Flow Regime Development in support of HDR Engineering Solutions Evaluation

May 2010

Science Subcommittee (SSC) Comments

Comal Comparison

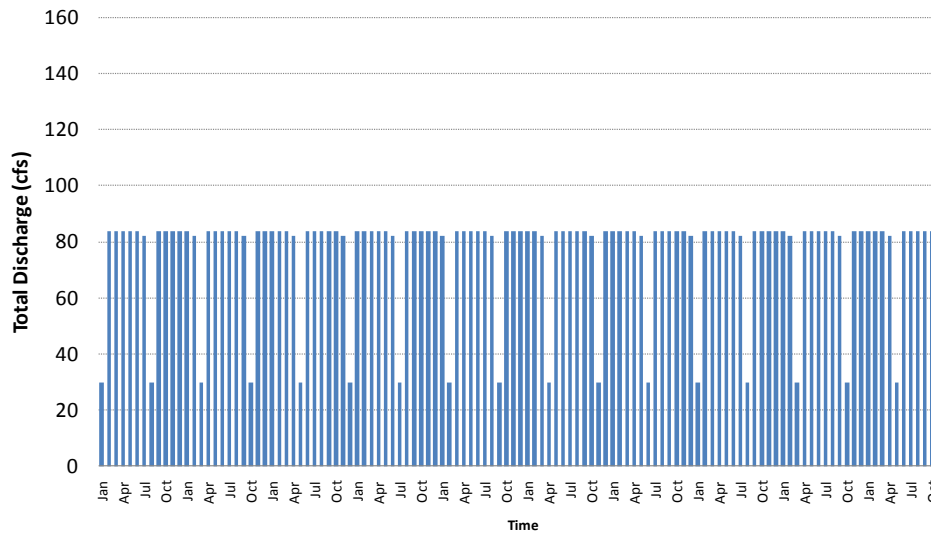
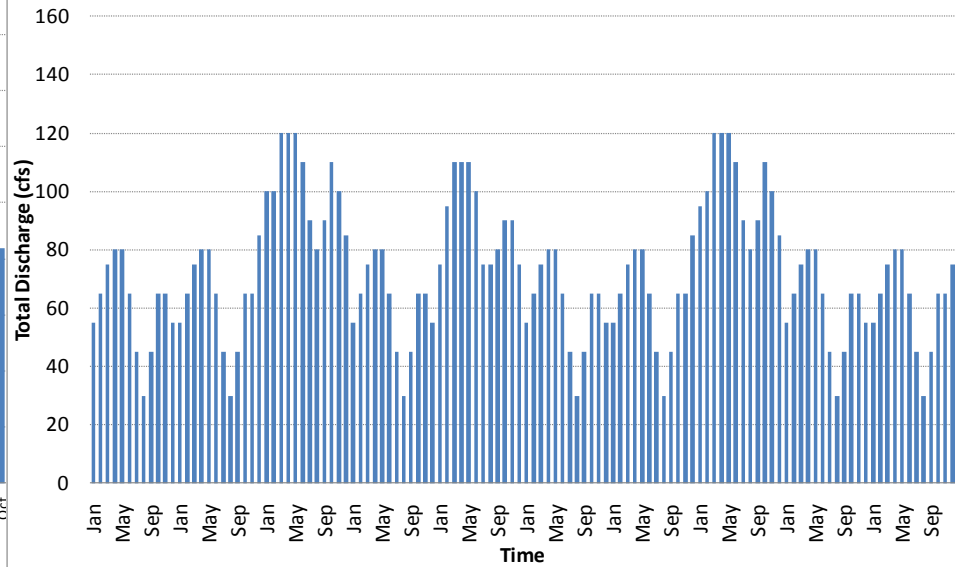
- **Major Differences:**
 - The purpose of this exercise was specifically to establish a flow regime during a severe drought that would keep the species alive in the wild with the potential for recovery afterwards. To be used in the HDR engineering solutions exercise.
 - The assumptions used in the Severe Drought regime go well beyond the status quo, thus allowing the regime to deviate from the SSC one-month and six-month values in certain instances.
 - The Severe Drought flow regime could be considered one possible translation of the SSC J charge recommendation, but with active adaptive management.
